STAFF RECOMMENDATION

816 Russell Street

October 21, 2020

<p>Description of Project: Application for the new construction of a rear addition.</p> <p>Recommendation Summary: Staff recommends approval with the conditions that the materials and design of porch steps, windows and doors is approved prior to purchase and installation; finding, that the project meets the design guidelines for new construction in the Edgefield Neighborhood Conservation Zoning Overlay.</p>	<p>Attachments A: Site Plan B: Elevations</p>
--	--

EXISTING & PROPOSED EXTERIOR ELEVATIONS A8

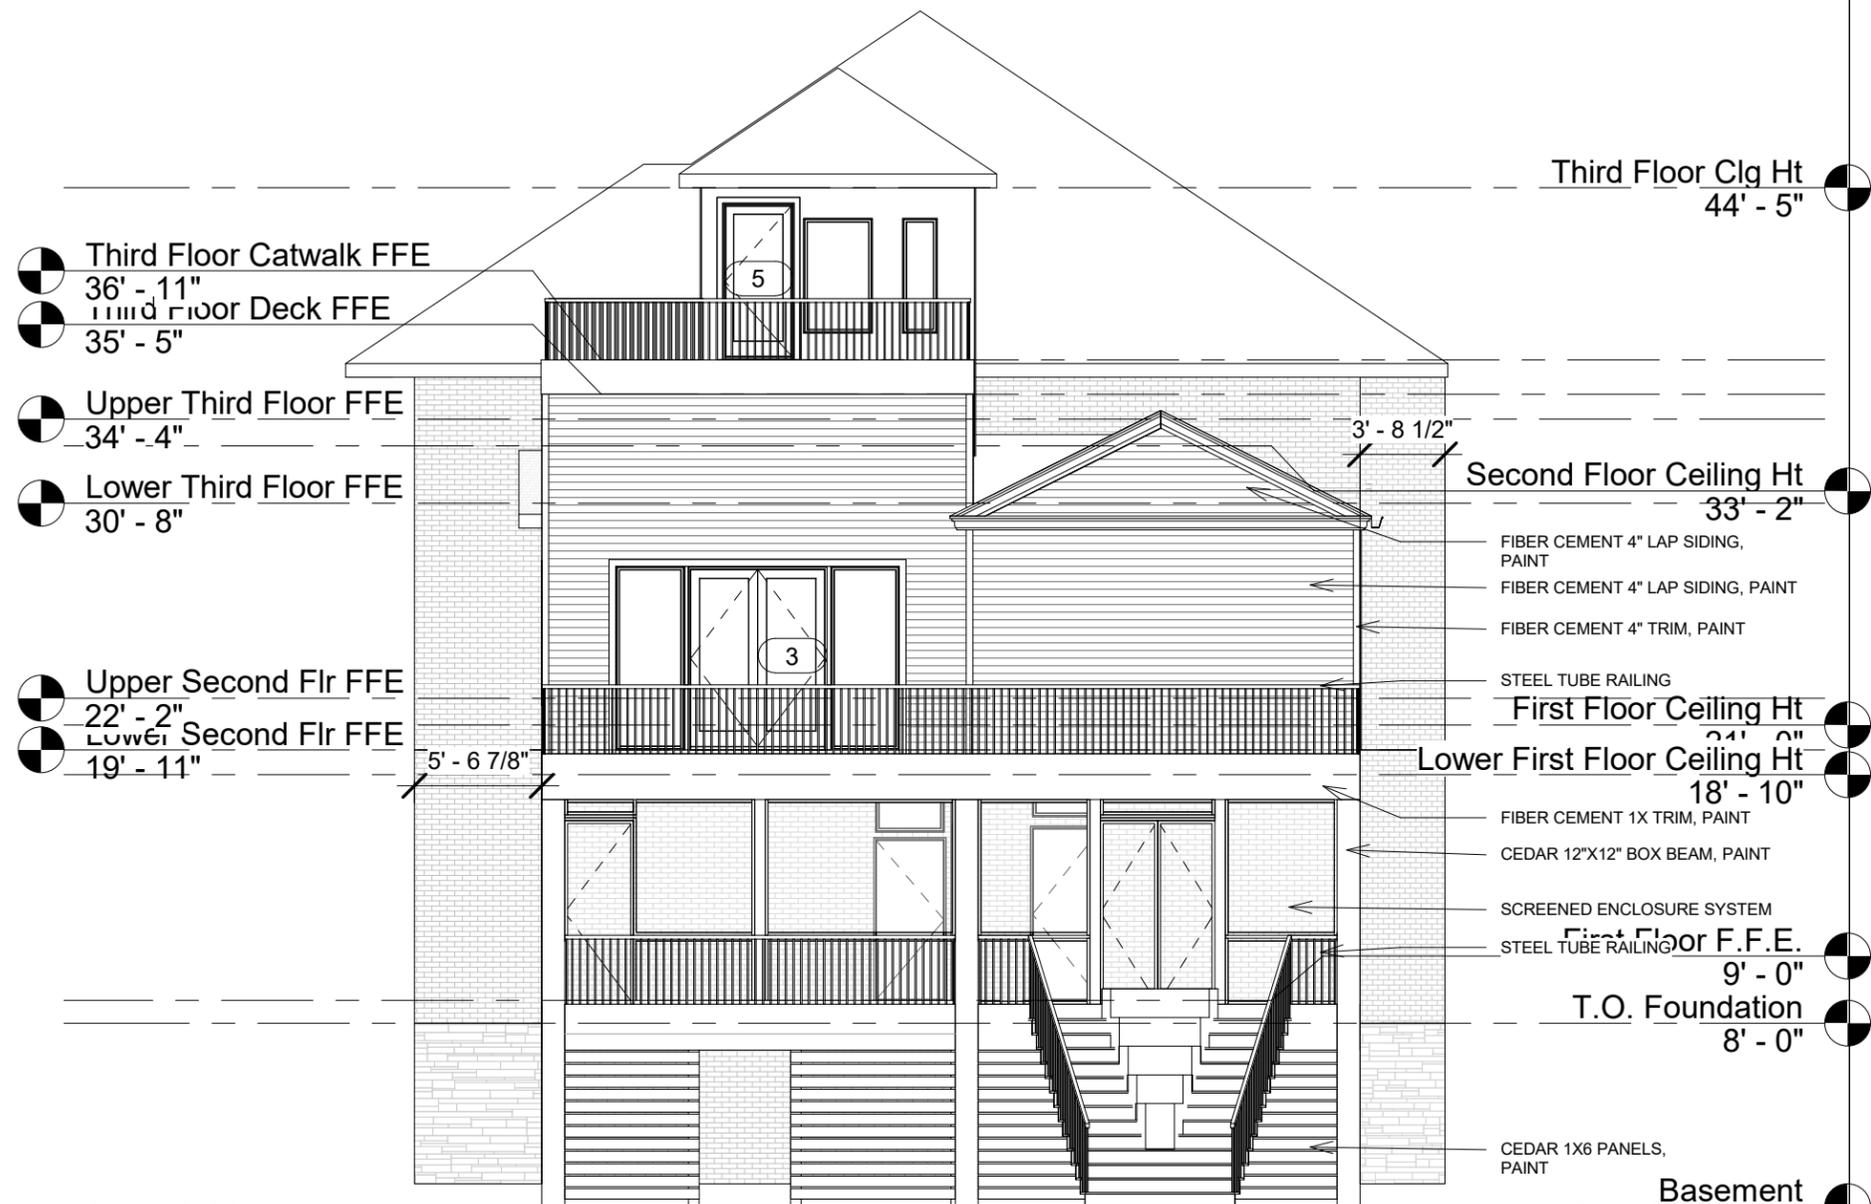
Demolition: The rear wall will remain primarily intact but with some minor revisions to the location of openings and to the rear dormer. As seen in Figure 3, the majority of the rear wall is no longer original. Because of alterations and the fact that the rear wall is not visible from a public right-of-way, partial demolition meets section VI.B for appropriate demolition.

1 Proposed Left / East Elevation
 1/8" = 1'-0"

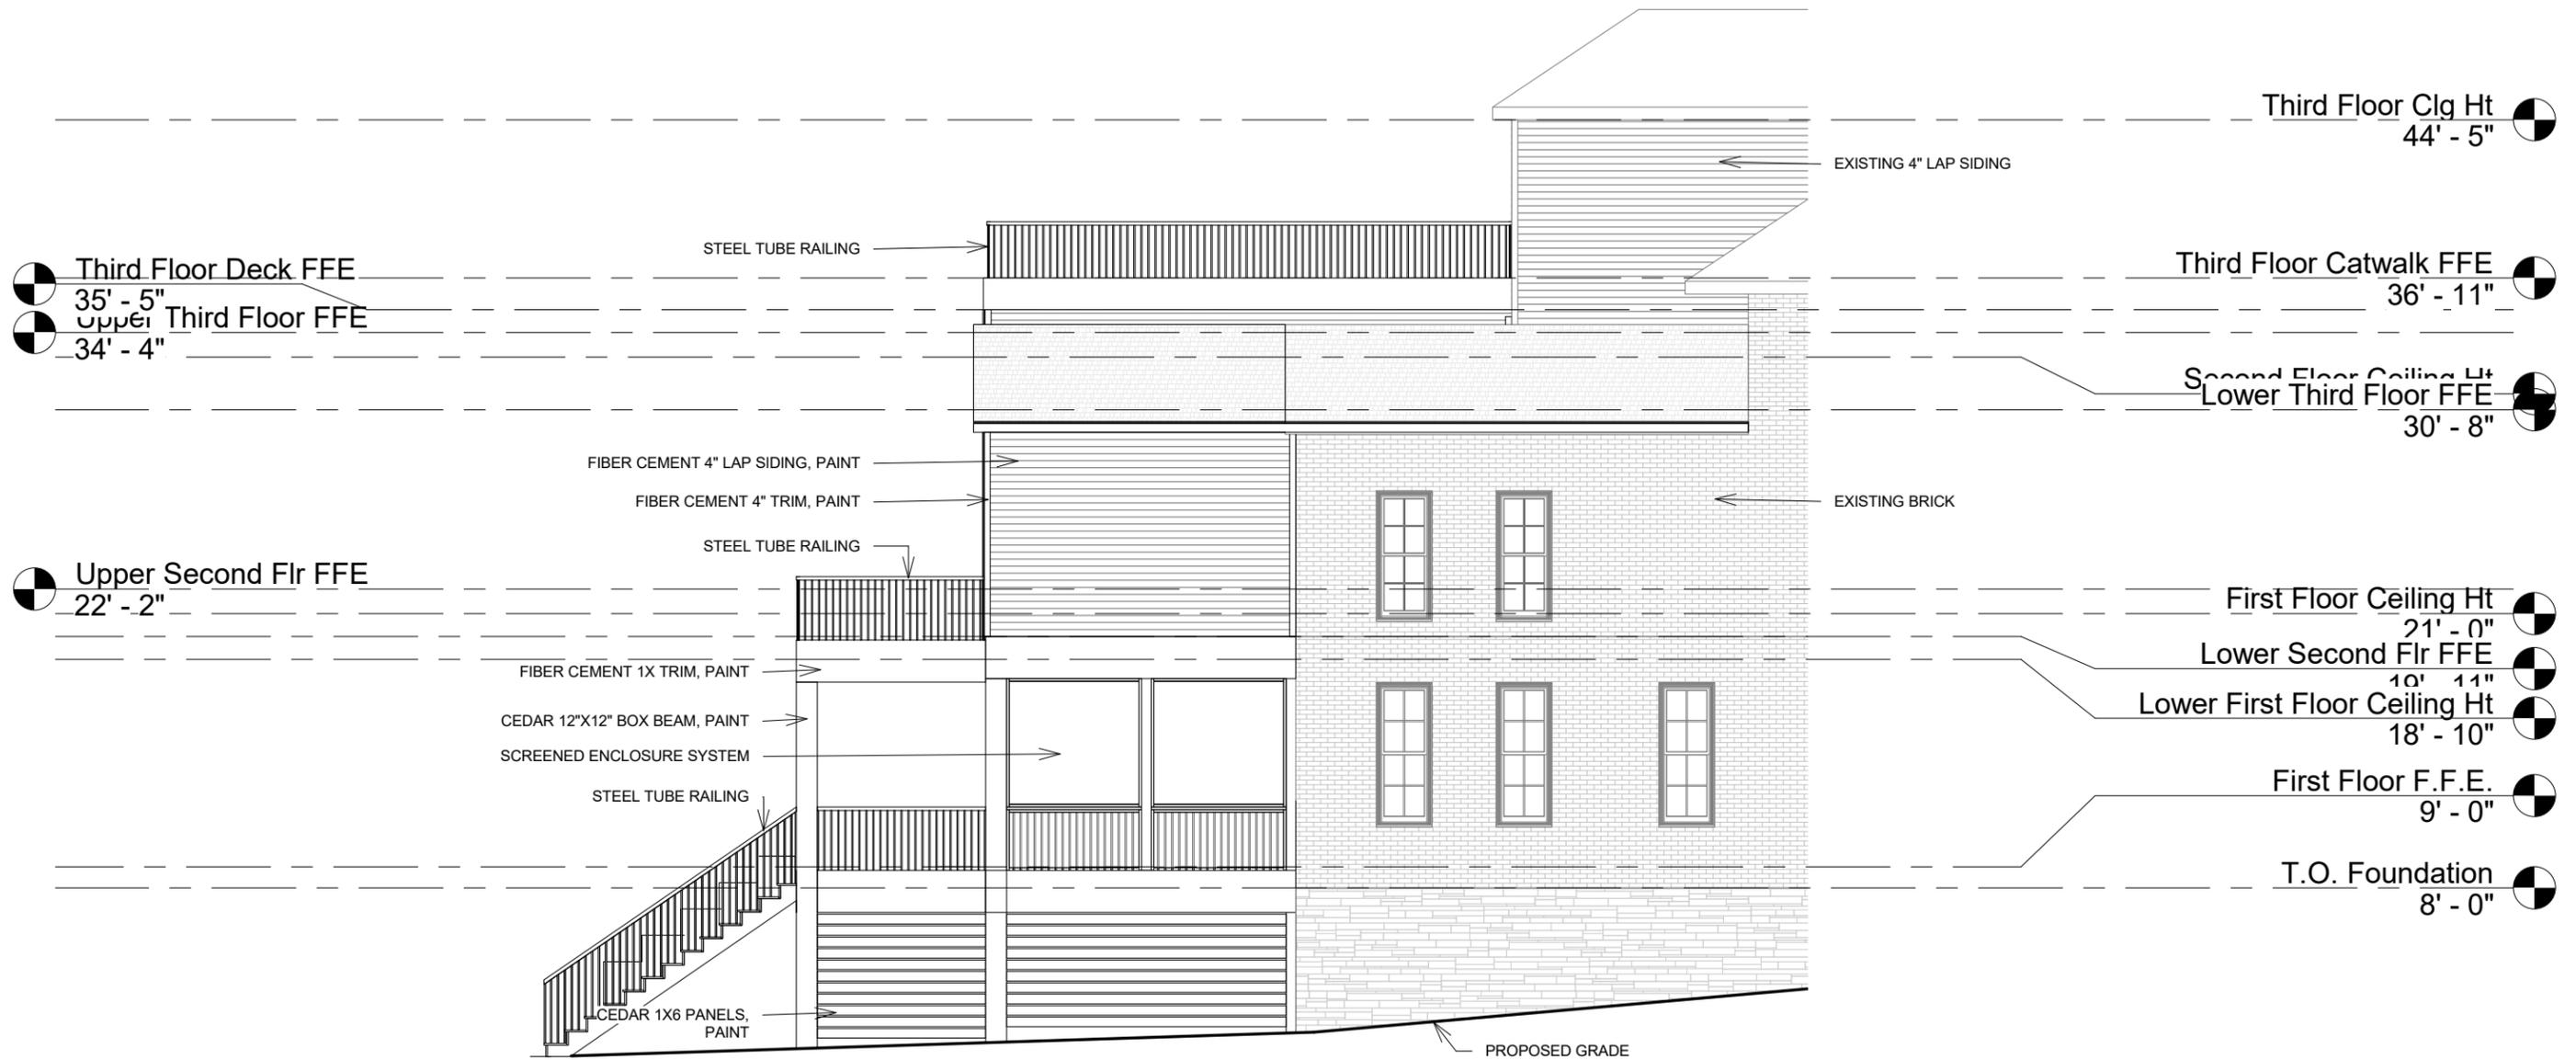
Height & Scale: Neither the height or the width of the proposed addition exceeds the height and width of the historic building. On the right-side, the addition sets in more than five and one-half (5.5') from the main wall of the historic building, where the Commission would generally require three feet (3'). There is no inset on the left side; however, the addition will be distinguished by a change of materials, is partially an open porch, and is only approximately twenty four feet (24') deep. In the past, the Commission has forgone the requisite insets that help to distinguish old and new when the addition is not very deep and there is a change in materials, both of which are the case for this addition.

Location & Removability: The location of the addition at the rear of the existing building is in accordance with the design guidelines. The addition's change in materials, inset on the left, separate roof form, and lower height help to distinguish it from the historic house and read as an addition to the house. With the exception of the roof form, the addition's scale, materials, and fenestration pattern are all compatible with the historic character of the existing house. The addition is designed so that if it were to be removed in the future, the historic character of the house would still be intact.

Roof form & Building Shape: The roof form of the proposed addition has two pitched roof sections and a flat roof section. The primary historic roof form is hipped with the rear section being pyramidal. Generally, flat roofed additions are not appropriate for buildings with a pitched roof; however, in this case the portion that is flat is only approximately four hundred and seventy-five square feet (475 sq. ft.) and is inset from the right side by approximately five and one-half feet (5.5') and on the left by eighteen feet (18'). The flat roof creates a roof deck on the third level, which is also generally inappropriate; however, the size is minimal, it is accessed from an existing rear dormer, and is fully located on the rear of the building. In addition, this house is very close on the right side to the neighboring two-story house, ensuring that the deck will not be seen from the public right-of-way.

Proportion and Rhythm of Openings: No changes to the window and door openings on the existing house were indicated on the plans. The windows on the proposed addition are all generally twice as tall as they are wide, thereby meeting the historic proportions of openings. There are no large expanses of wall space without a window or door opening.

Staff recommends approval with the condition that the materials for the rear porch steps, window and doors are approved prior to purchase and installation, as they were not indicated on the plans. With those conditions, the project meets section III.B.2.g.
